Lighting Design Analysis Report

Selmon Expressway Aesthetic Lighting Base Bid

Prepared for Tampa Hillsborough Expressway Authority

March 2020

Minimum Clearance on Top of Pier Column to Install Anchor Bolts

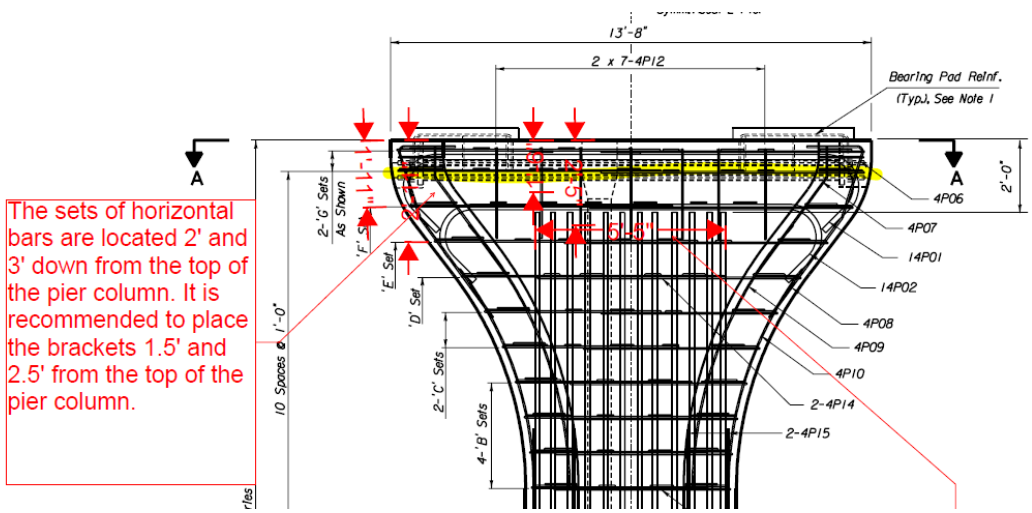
The current aesthetic lighting structural connection at the typical pier locations is shown on plan sheet no. 49. It consists of two mounting brackets with anchor bolts into the pier column per vertical post. This structural connection is mirrored so that is located on both the upstation and downstation face of the pier column. This concept is shown in the three figures below.

The bottom frame that supports the aesthetic lighting luminaires is wide and extends past the pier column. Due to its geometry, it will be subjected to lateral and uplifting wind loads that will produce a torque or wracking of the entire aesthetic lighting support frame. If the vertical posts that extend up and over the top of the pier are not mechanically fastened to the pier column (e.g. anchor bolts into the pier column), the entire support frame will be subject to movement during wind events. In order to prevent this movement, mechanical fasteners/anchor bolts would still be required to fix the support frame to the pier column. Another option would be to implement a thread bar system that would connect the support frames on either side of the pier. The thread bar system would run external to and alongside of the pier column to connect the support frames and providing a clamping force. Because these bars

would be external, this would not be an aesthetically pleasing solution.

Based on studying the feasibility of extending the vertical posts up and over the top of the pier column, Kimley-Horn recommends to move forward with the existing concepts where the vertical posts are mechanically fastened to the side of the pier column with anchor bolts. Rebar locating methods using nondestructive techniques are readily available (e.g. ground penetrating radar "GPR" methods) to locate the reinforcing steel and locate where the anchor bolts need to be placed. Locations and dimensions are provided in the aesthetic lighting support frame plans for the contractor to start with their rebar locating methods. The aesthetic lighting support frame will be detailed so that it can accommodate any deviation to the transverse distance between the vertical posts (currently 4'-0") and the brackets supporting the vertical posts (dimensioned from the top of the pier column).
